RE: **Winrock Road Town Center**
2100 Louisiana Blvd NE
Drainage Master Plan- Drainage Implementation Plan
Engineer's Stamp Date: 5/16/19
Hydrology File: J19D058

Based on submittal received on 5/17/19, the Drainage Implementation Plan cannot be approved for Site Plan for Building Permit until the following are corrected:

RE: Winrock Town Center Drainage Implementation Plan
Hydrology File: J19D058

WINROCK TOWN CENTER DRAINAGE IMPLEMENTATION PLAN

WINROCK TOWN CENTER			
PHASE B INFRASTRUCTURE IMPROVEMENTS			
TITLE: STORM DRAIN AP-B 400 & 500			
Design	Review	Committee	City Engineer
Last Update		Ms./Day/Yr.	
		Ms./Day/Yr.	
City Project No.		Zone Map No.	Sheet Of
4553.90		J-19-Z	EXHIBIT 4

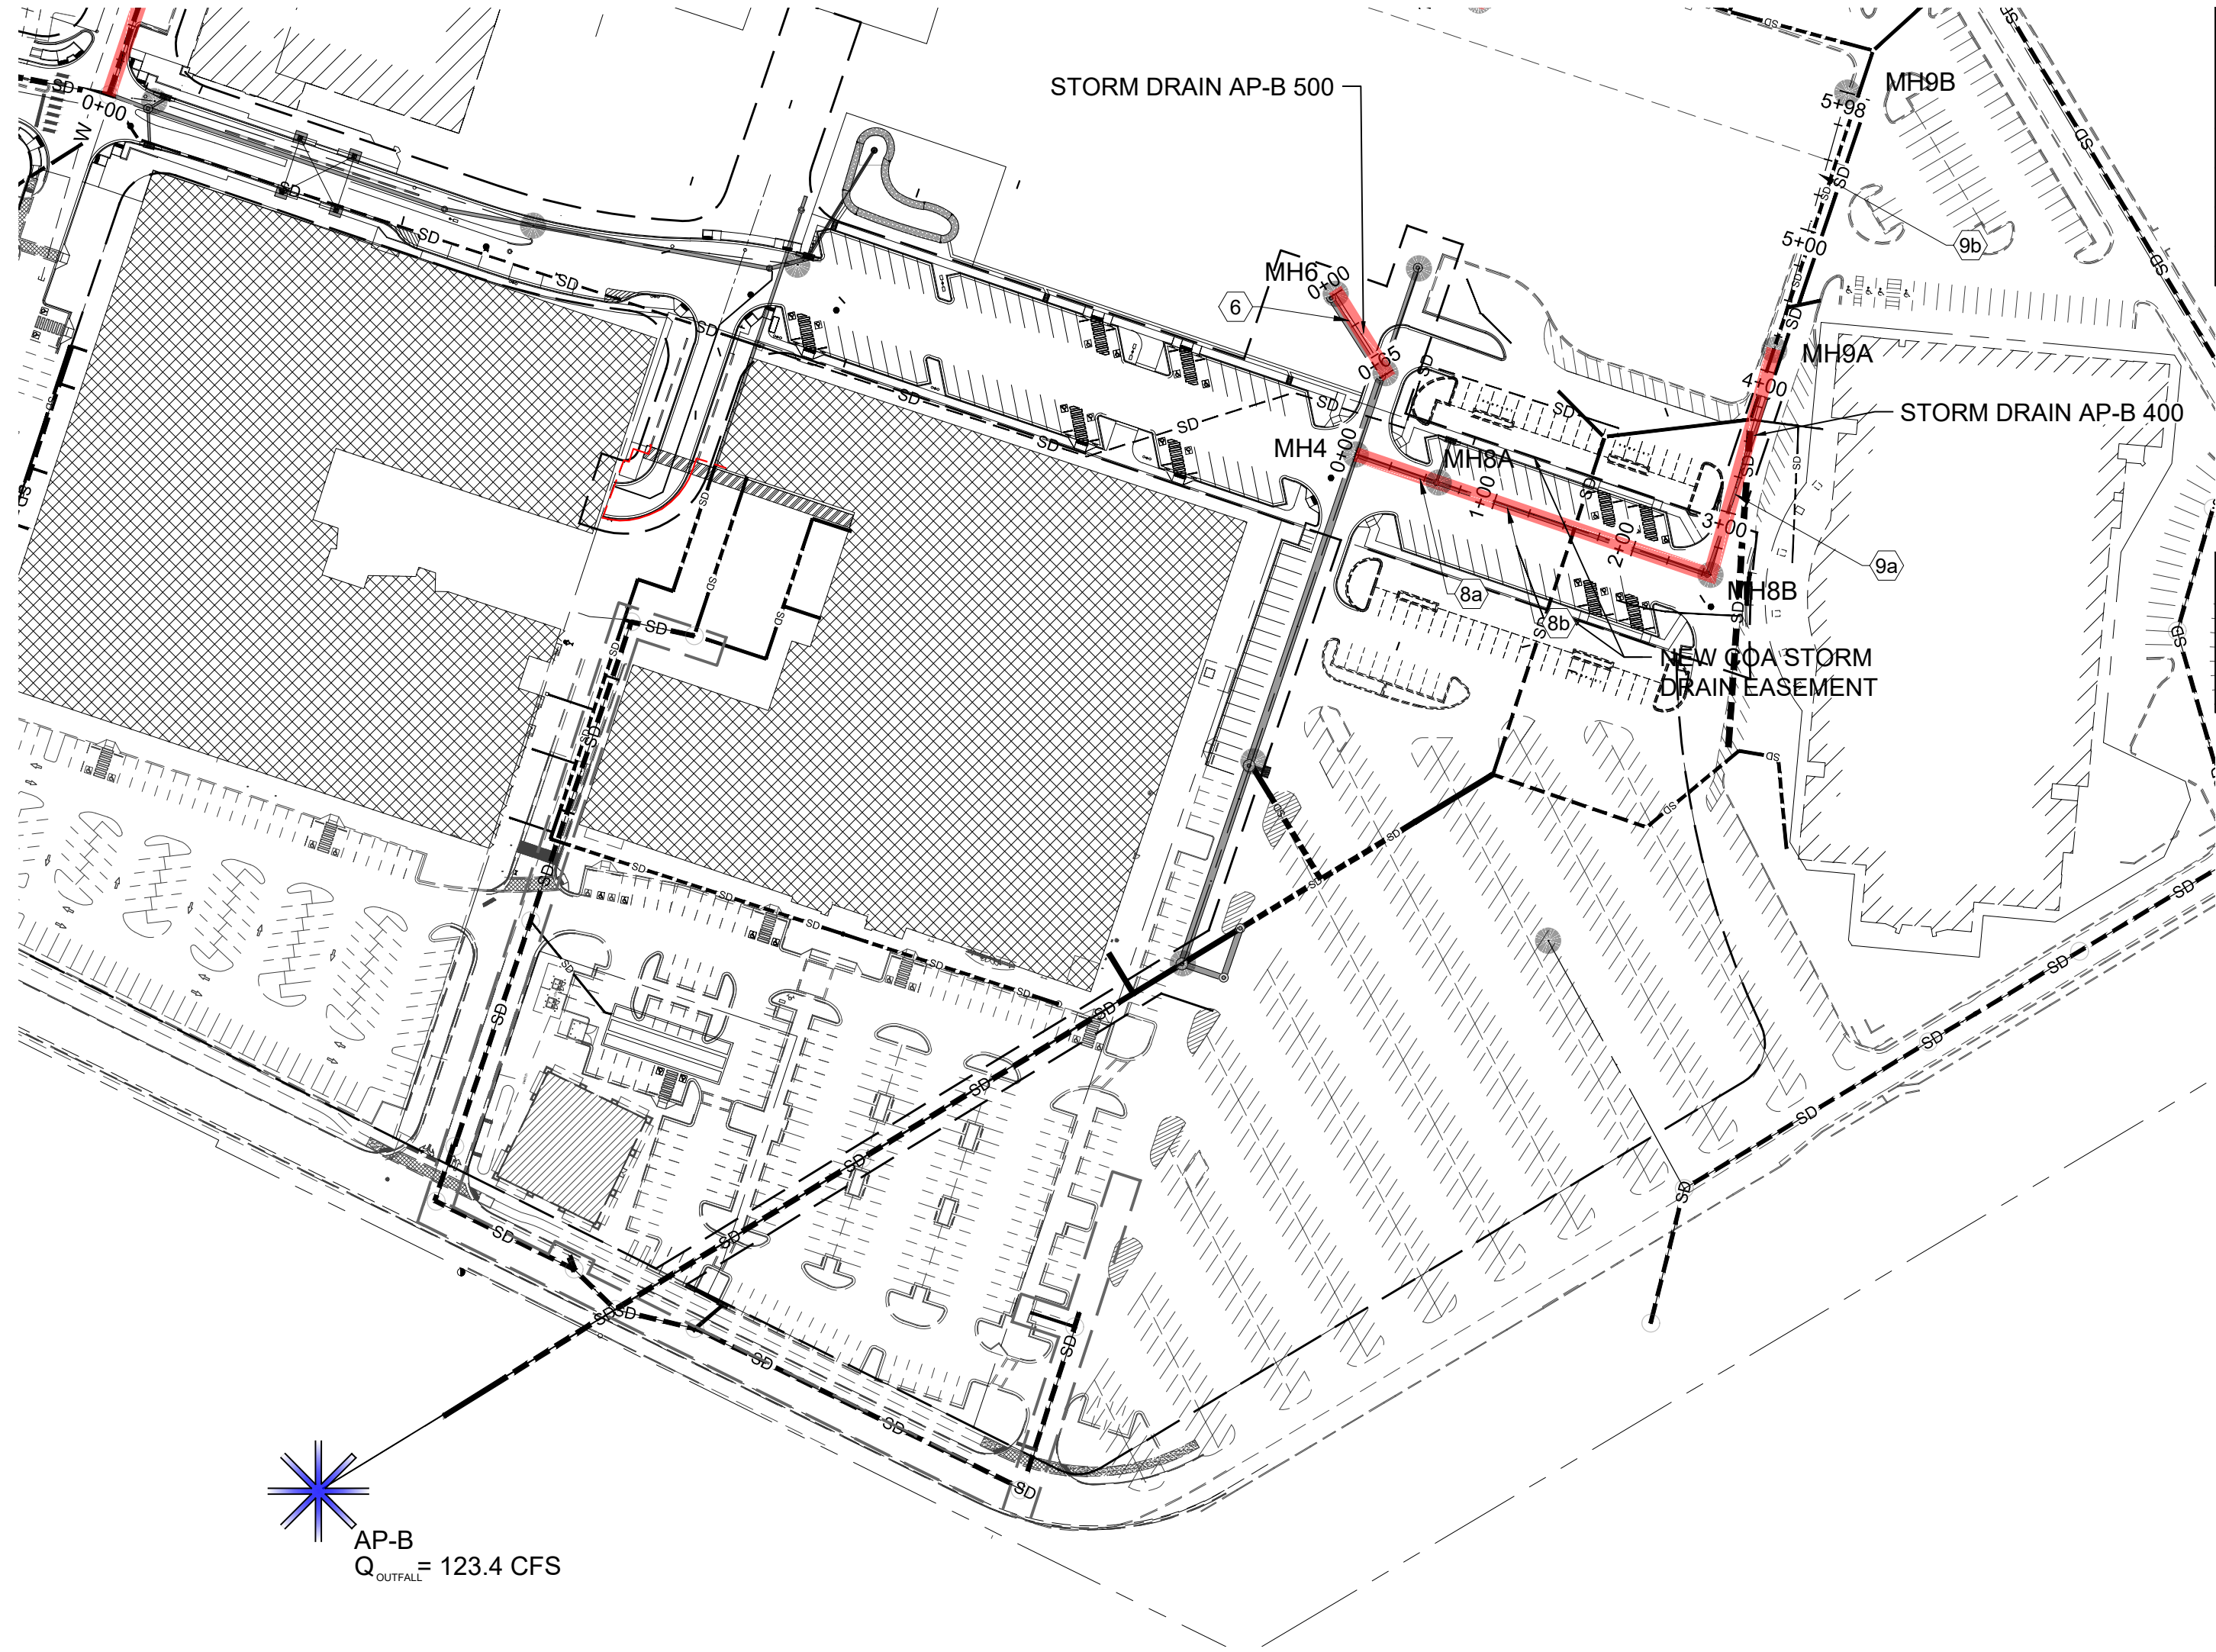
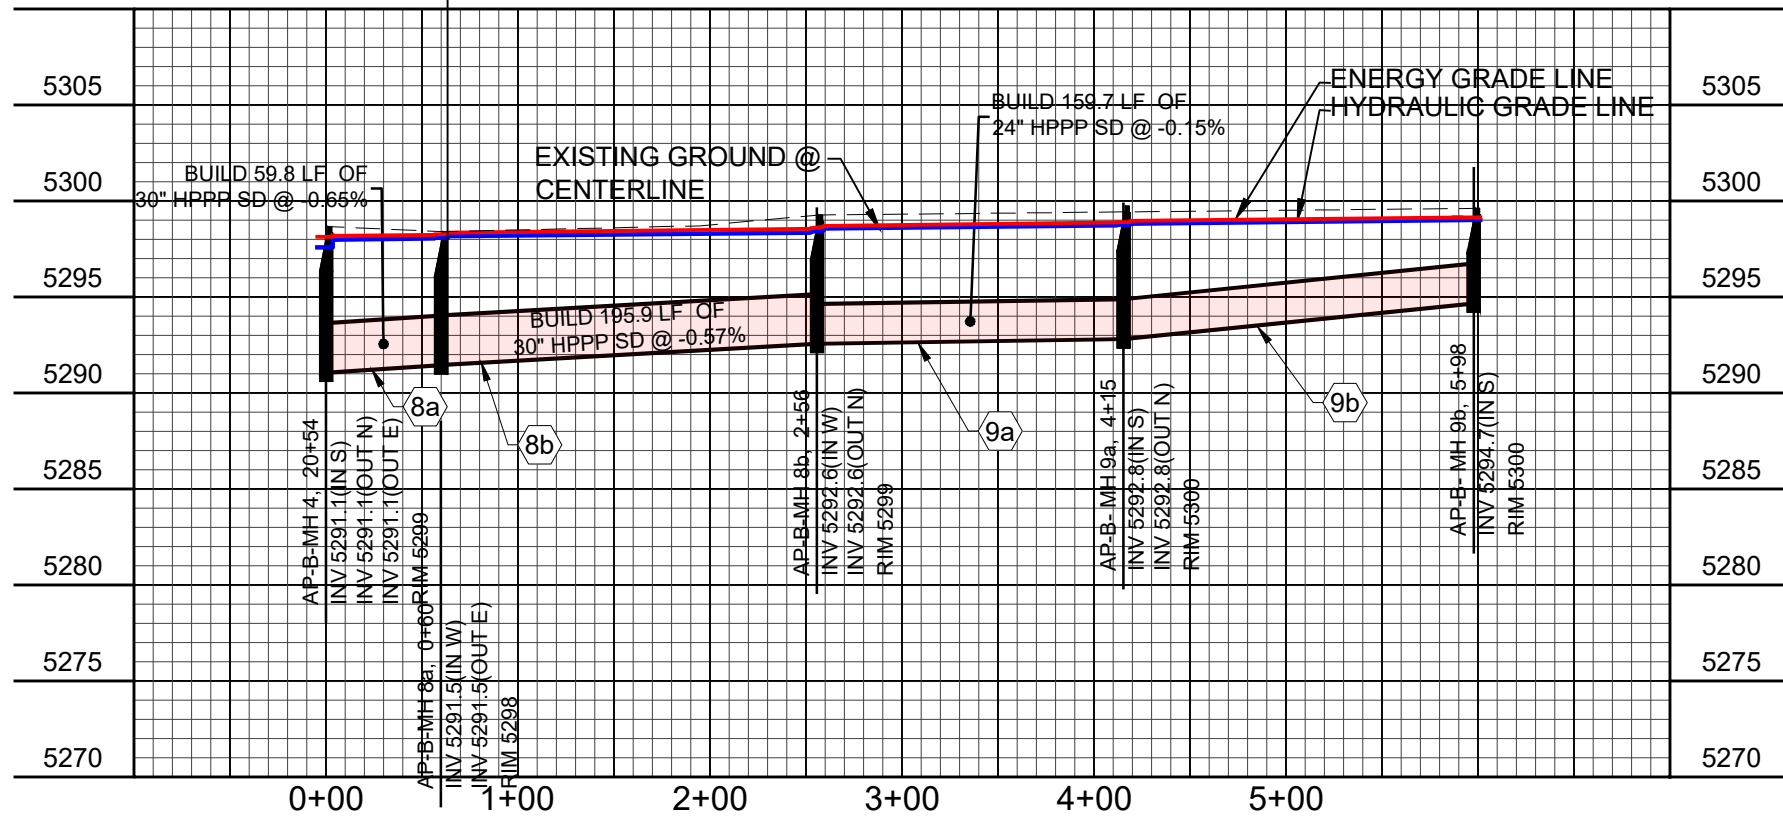
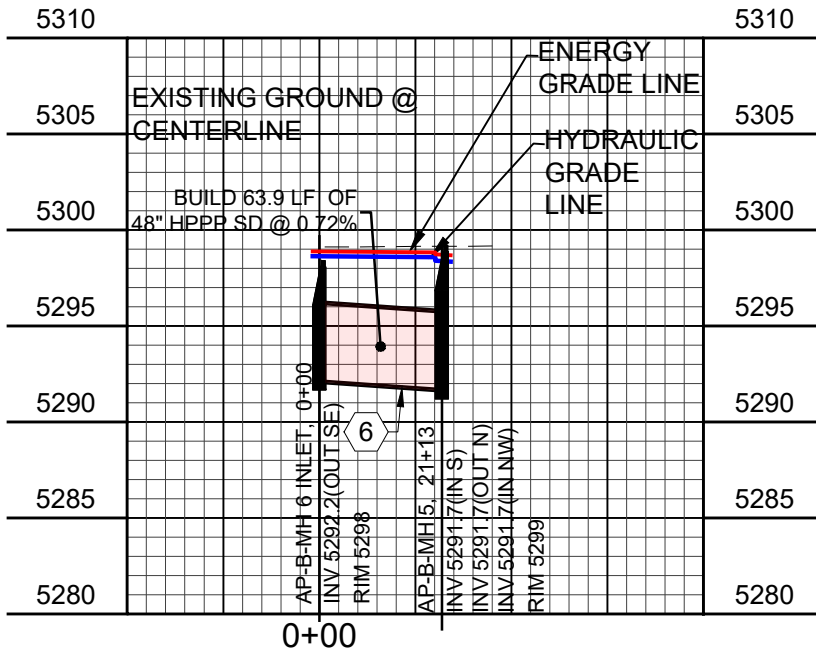
- iii. pipe 16 Q is 14.3cfs, but is shown as 22cfs on the exhibit 1 table.
 - d. On Exhibit 4,
 - i. pipe 6 is called out as 48" in profile and on the exhibit 1 table, but is 36" in the table;

- ii. pipe 6 Q is shown as 24cfs on the table, but is shown as 51cfs on the exhibit 1 table.
 - e. On Exhibit 5, pipe 7a-7e are called out as 30" in profile, but are 24" in the table and 42-30" on the exhibit 1 table

- a. *Please label the manholes in plan view and label the pipes in profile view.*
- b. *On Exhibit 2, Pipe 2 appears to be mislabeled in plan view.*
- c. *Exhibit 4, the profile for AP-B 400 is cropped.*
- d. *Storm drain profile/model for AP-A is missing.*

The exhibits have been corrected and updated.
